Product Discontinuation Notice

LED-Lit Push-Button Switches and Indicators “Series 2”

Replaced by New model “SP Series”

EXTERNAL DIMENSIONS

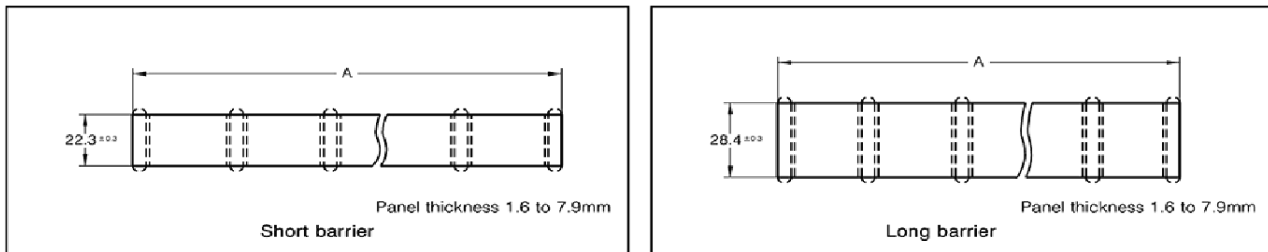
Same panel cutout dimensions of Series 2 Barrier type unit (S2C/S2F-L1 • L2)

SP series has also Short barrier and Long barrier, can be mounted the same way as Series 2.

SP series are able to mounting on the panel without barrier, Barrier type unit is compatible with Series 2 as above.

SP series has 3xSPDT. (Series 2 has 4xSPDT)

SP series has no flange type.

SP series has no Low force momentary type.

SP series has no Momentary-Alternate operation mechanism.

SP has no high load operation(AC250V 10A) screw terminal as V-3000 miniature switch unit.

SP series has one button design. (Series has two button design. (Design A and B)

SP series has no Hold-in coil.

SP series has one guard cover for short barrier type only.

(Series 2 has three guard cover for short barrier and long barrier, common type.)

SP series has no 24V AC lighting type.
